ENVIRONMENTAL STATEMENT ADDENDUM

PLOT SGR1, BICESTER

OCTOBER 2018

Figure 2.1: Revised Figure 5.1 – Parameter Plan 011: Land Use (with Amendments)

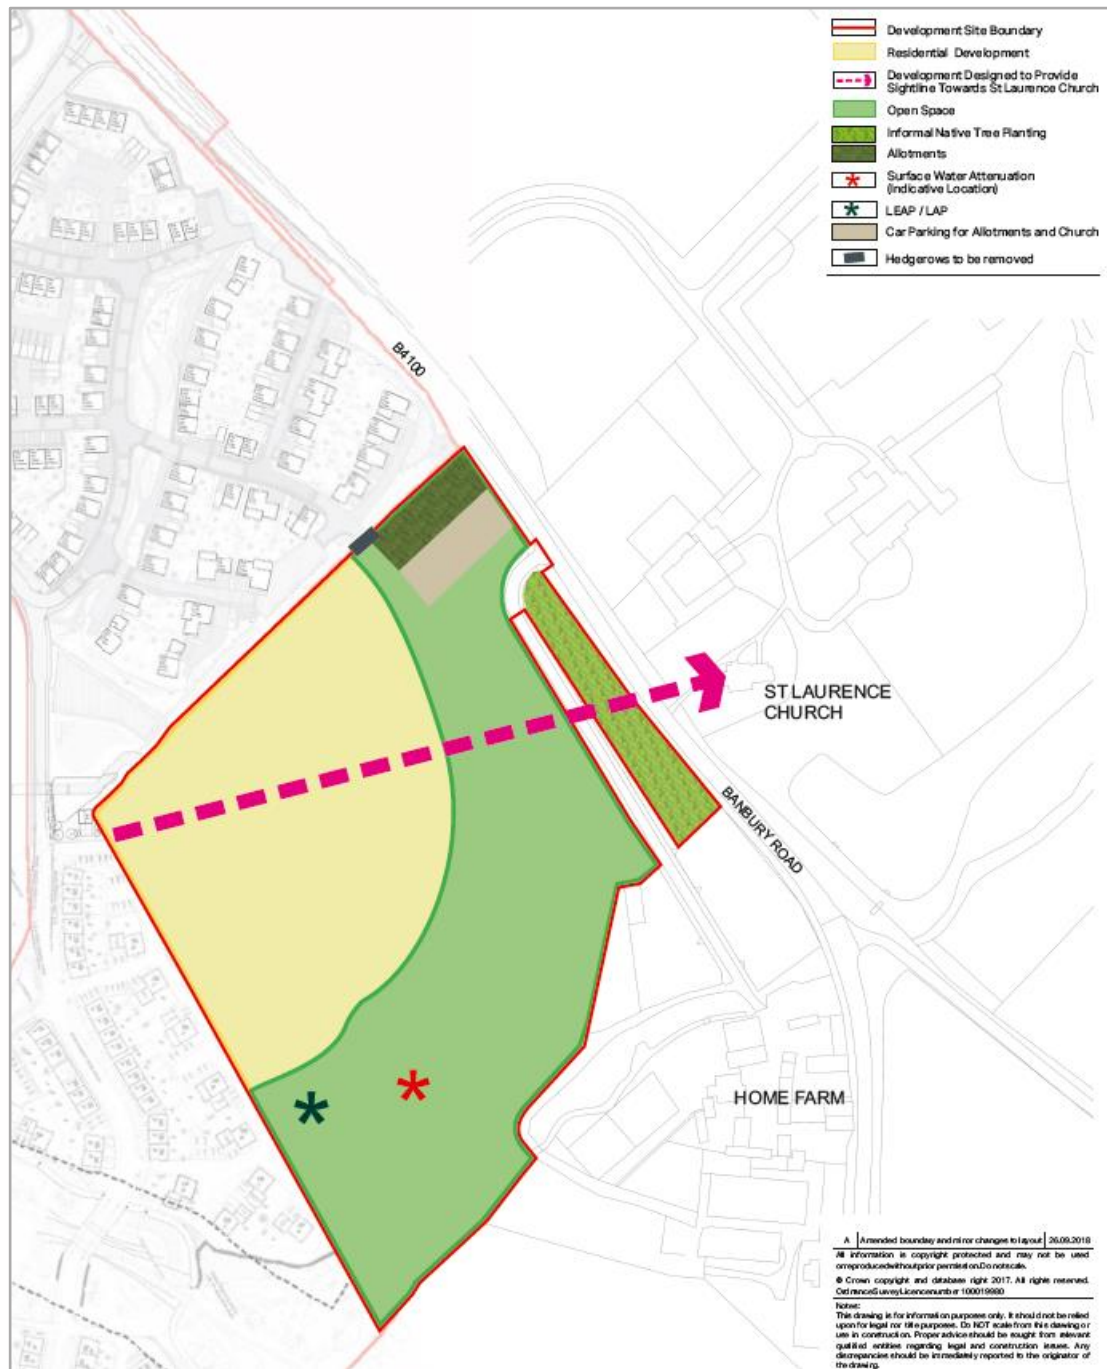
- Revision of the Site boundary to incorporate access to Home Farm and provide access from Banbury Road (B4100);
- Relocation of the Local Equipped Area for Play (LEAP) from the northern corner to the southern corner of the Site. This would provide better integration and approximately 500m² of a combined Local Area for Play (LAP) and LEAP, with a 20m offset to the nearest habitable rooms;

- Substitution of proposed orchard planting along the north-eastern Site boundary with informal native tree planting. This planting would still allow for a view corridor to the church;

- Relocation of trees from the northern to the southern edge of the central residential avenue;
- Revised indicative location of the Sustainable Urban Drainage (SuDS) basin, relocating it partially to the north-east. However, its size would remain unchanged; and

Figure 2.2: Revised Figure 5.2 – Parameter Plan 012: Access and Movement (with Amendments)

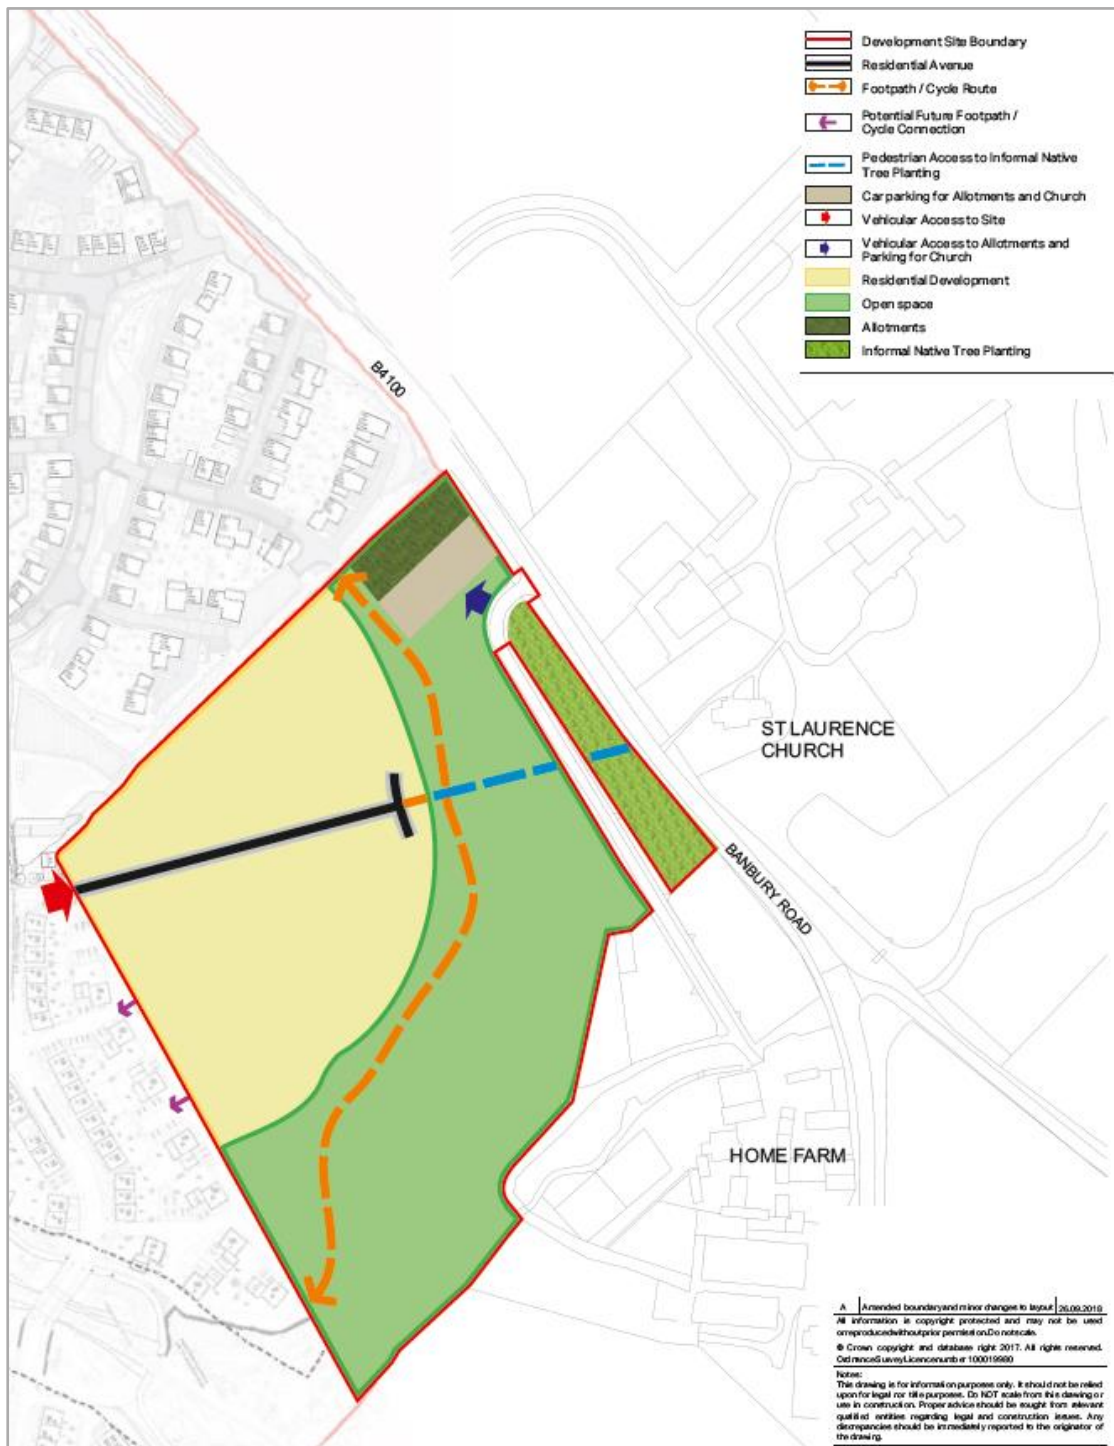
- Inclusion of provision for potential future pedestrian and cycle connections to adjacent links to the west.
